Denison Mines (USA) Corp.
1050 17th Street, Suite 950
Denver, CO 80265
USA

**Re: Response to March 19, 2012 DRC/URS Comments on Nitrate Corrective Action Plan –
Docket No. UGW09-03**

Please find enclosed Denison Mines (USA) Corp.'s ("Denison's") revisions, dated May 7, 2012, to the *Nitrate Corrective Action Plan for the White Mesa Mill Site* (the "Plan").

Denison Mines (USA) Corp. 	
Project:	AMMONIUM SULFATE NITRATE CONTROL
County:	San Juan
State:	Utah
FIGURE 11-2A AMMONIUM SULFATE TANK AREA (CURRENT LAYOUT)	
Date:	Desig'n:
	Drafted By: S. SNYDER

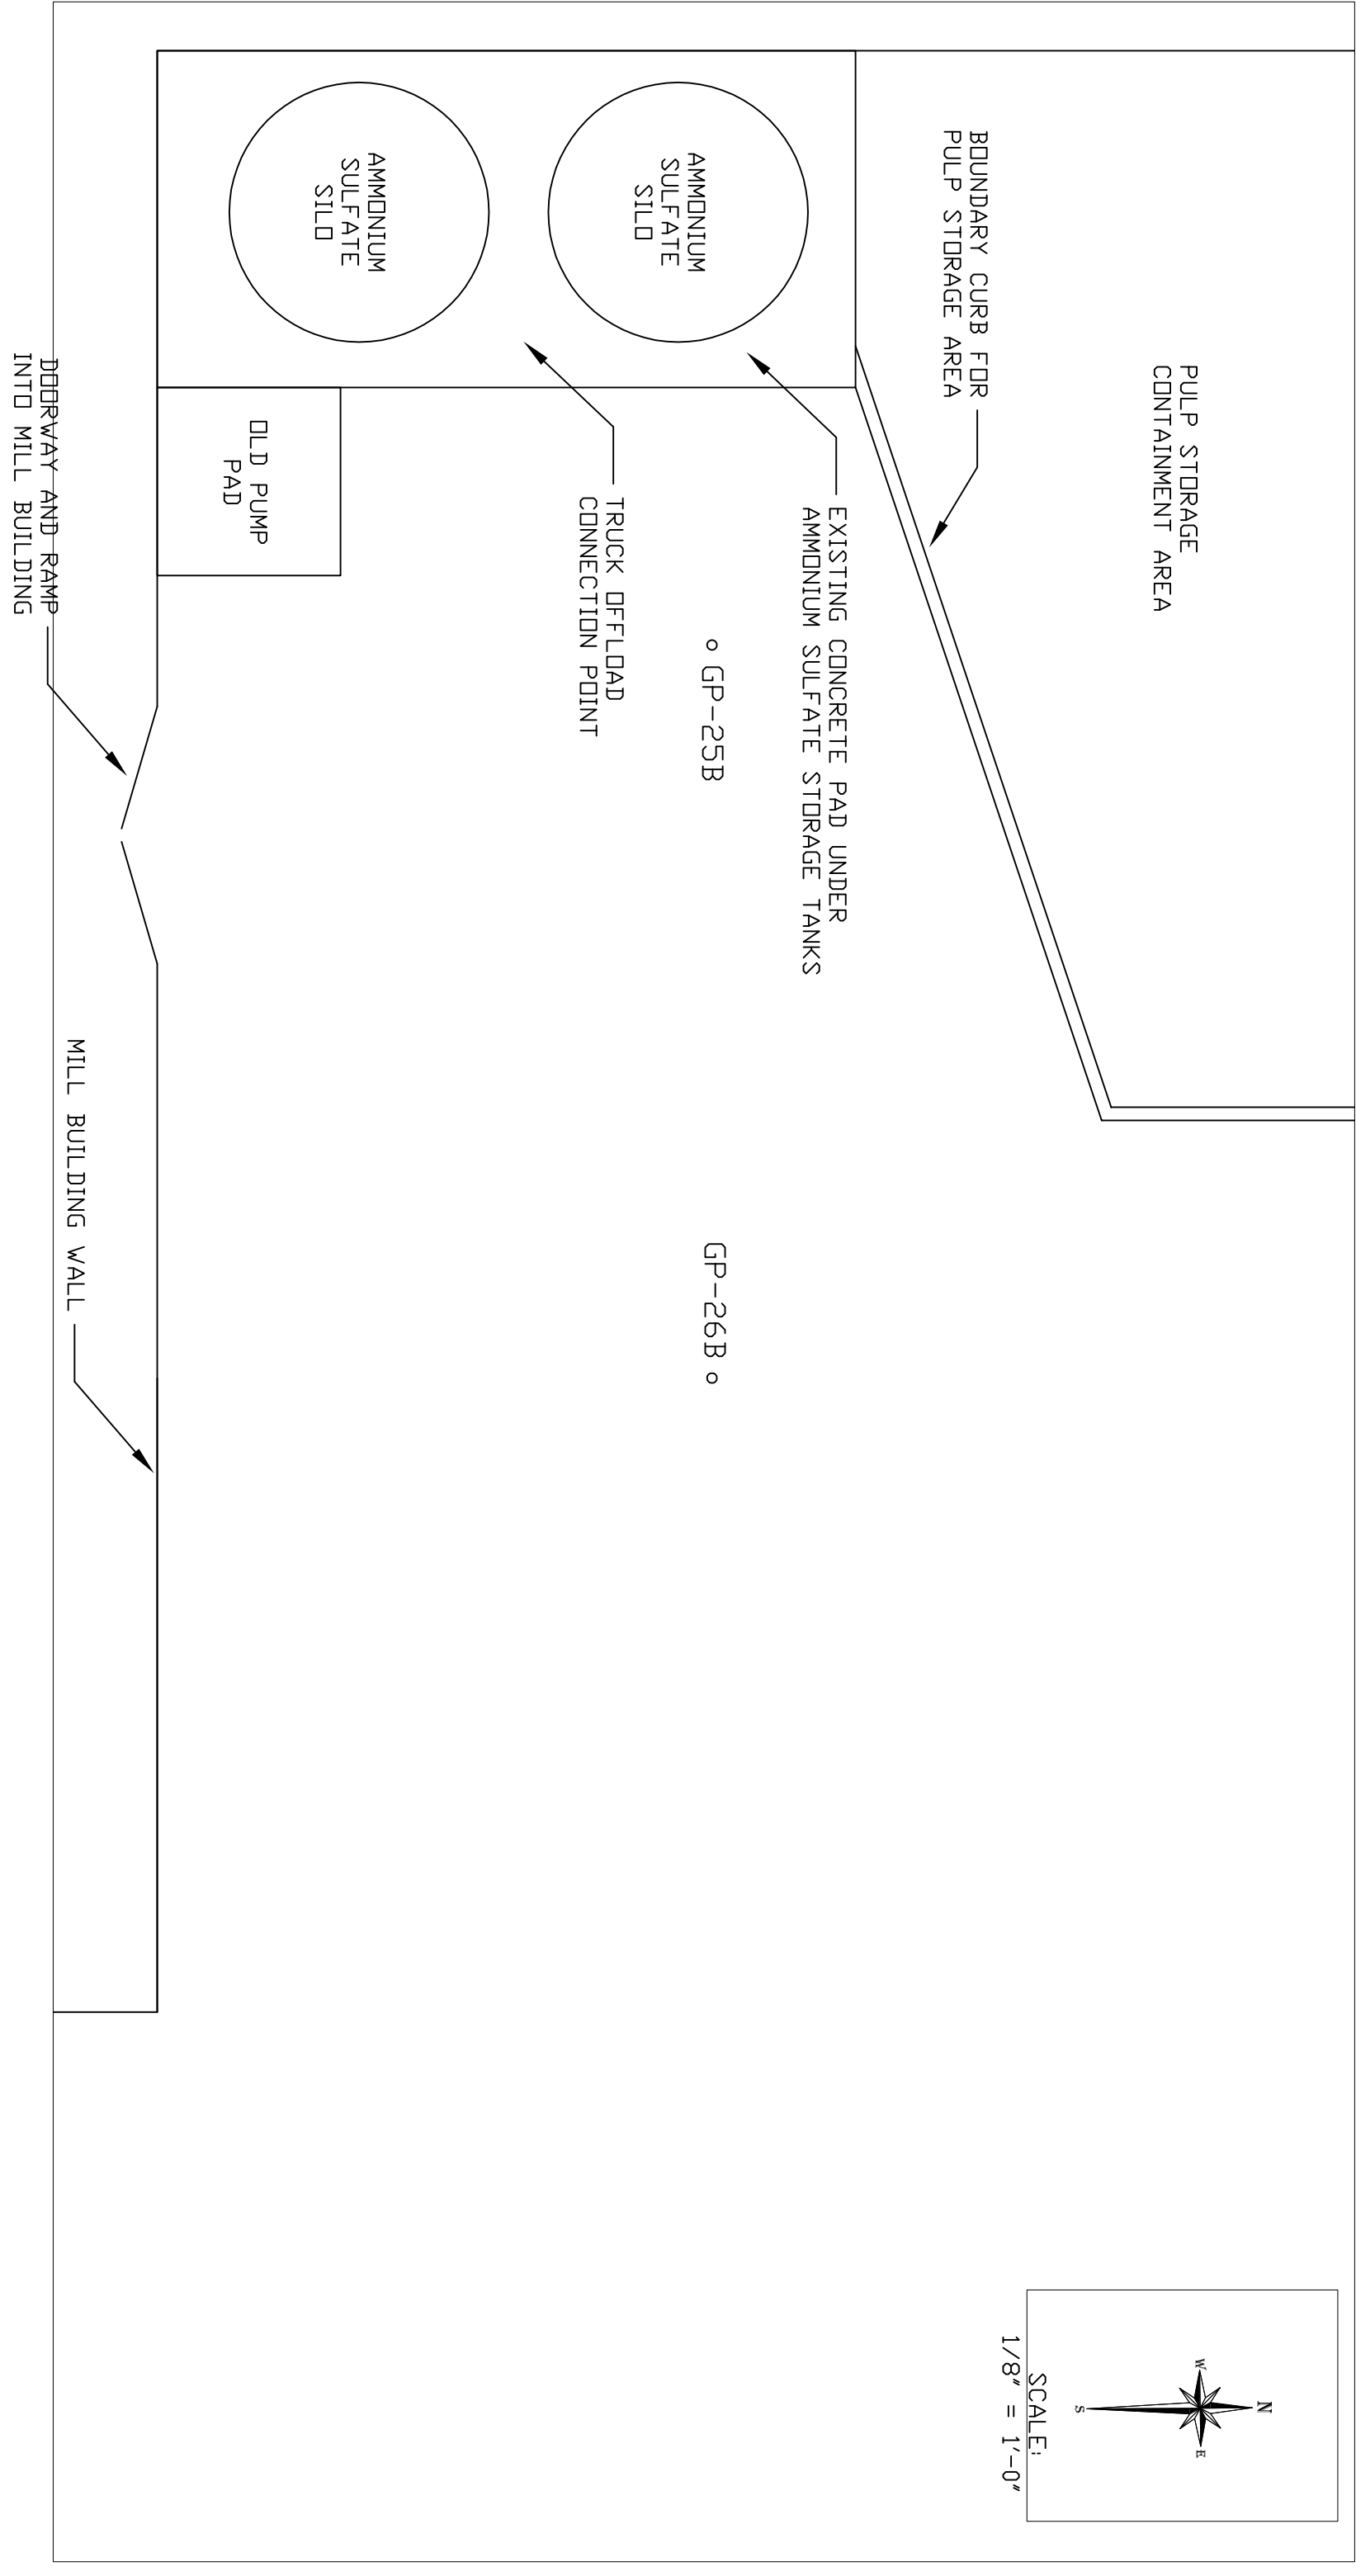
8. *Figures 11-2A and 11-2B: It would be helpful to show sample locations GP-25B and GP-26B on these drawings.*

Denison Response: Sample locations for GP-25B and GP-26B have been added to Figures 11-2A and 11-2B as requested.
